Access Compliance Report Public Rights-of-Way (Curb Ramps)

Main Street: WASS_ST Cross Street: NEWPORT_AVE Location: SW

ADA ID: RPRK211011152254 Ramp Type: Type 1 - Perpendicular Diagonal Initial Pass/Fail: Fail Overall Compliance: No Severity Score: 15

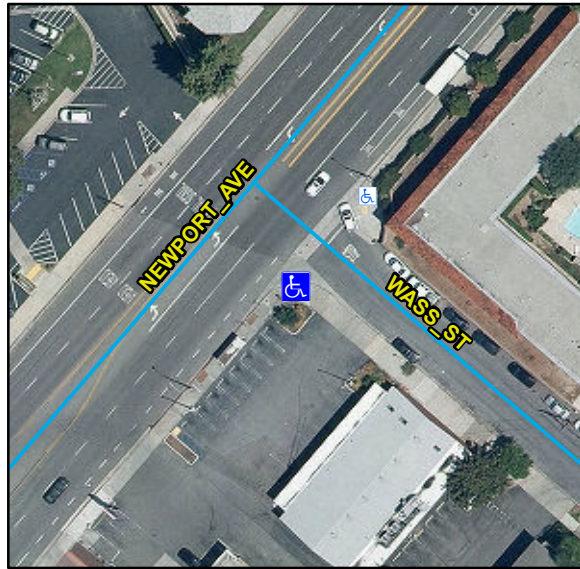
Compliance	Description	Data	Compliance	Description	Data
N/A	Ramp Length (in)	108	N/A	Flare Type LT	
Yes	Ramp Width (in)	48			N/A
No	Ramp Run Slope (%)	8.5	N/A	Flare Slope LT (%)	N/A
Yes	Ramp Cross Slope (%)	1.1	N/A	Flare Traversable LT	N/A
N/A	Landing Present	N/A	N/A	Flare Type RT	
N/A	Landing Length (in)	N/A			N/A
N/A	Landing Width (in)	N/A	N/A	Flare Slope RT (%)	N/A
N/A	Landing Run Slope (%)	N/A	N/A	Flare Traversable RT	N/A
N/A	Landing Cross Slope (%)	N/A	N/A	DWS Provided	N/A
N/A	Landing Movement Obstructed?	N/A	N/A	DWS Contrast	N/A
	Landing Movement Type	N/A	N/A	DWS Length (in)	N/A
N/A	Landing Shared	N/A	N/A	DWS Full Width	N/A
N/A	Clear Space	Yes	N/A	DWS Offset Left (in)	N/A
N/A	Clear Space To Crosswalk (in)	N/A	N/A	DWS Offset Right (in)	N/A
N/A	Marked Crosswalk 1	No	N/A	Marked Crosswalk 2	No
	Crossing 1 Direction	E		Crossing 2 Direction	N
	Marked Crosswalk 1 Width (in)	N/A		Marked Crosswalk 2 Width (in)	N/A

N/A	Ramp Inside Crosswalk 1	N/A	Yes	Ramp Inside Crosswalk 2	N/A
	Crossing 1 Slope (%)	6.4		Crossing 2 Slope (%)	0.4
	Crossing 1 Cross Slope (%)	1.5		Crossing 2 Cross Slope (%)	0.6
N/A	Gutter Ponding	N/A	No	Curb Slope	5.9
No	Gutter Lip Height (in)	0.25		Road Run Slope (%)	0.3
N/A	Gutter Run Slope (%)	N/A		Road Cross Slope (%)	2.3
N/A	Gutter Cross Slope (%)	N/A			
Yes	Overall Surface Condition: Acceptable		Yes	Perp Joint Present	Yes
	Cross Gutter Present?	Yes		Spandrel Present?	Yes
	Replace Cross Gutter?	No		Replace Spandrel?	No

Remove & Replace Curb Ramp With Two New Directional Ramps or Equivalent.

R304.2.2, R302.7.2, STD 1115
